UN Regulation No. 134 (Hydrogen and fuel cell vehicles)

**Proposal for the 03 series of amendments to UN Regulation
No. 134 (Hydrogen and fuel cell vehicles)****Submitted by the experts from the International Organization of Motor
Vehicle Manufacturers (OICA) and the Task Force amending UN
Regulation No. 134 (TF-R134)***

Model A

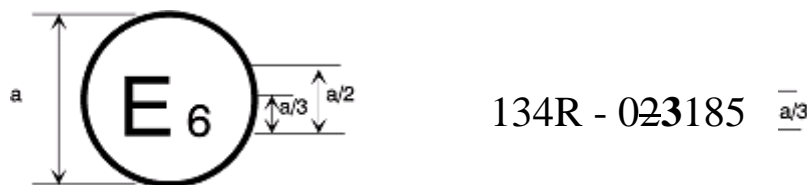
The above approval mark affixed to a vehicle/ storage system/specific component shows that the vehicle/storage system/specific component type concerned has been approved in Belgium (E 6) for its the safety-related performance of hydrogen-fuelled vehicles pursuant to Regulation No. 134. The first two digits of the approval number indicate that the approval already contained the 023 series of amendments at the time of approval.

Model B

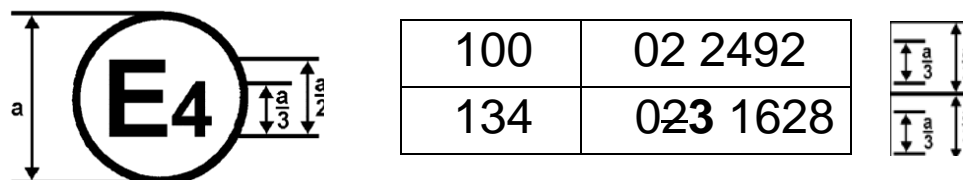
The above approval mark affixed to a vehicle shows that the road vehicle concerned has been approved in the Netherlands (E 4) pursuant to Regulations Nos. 134 and 100.* The approval number indicates that, at the dates when the respective approvals were granted, Regulation No. 100 was amended by the 02 series of amendments and Regulation No. 134 was amended by the 023 series of amendments.”
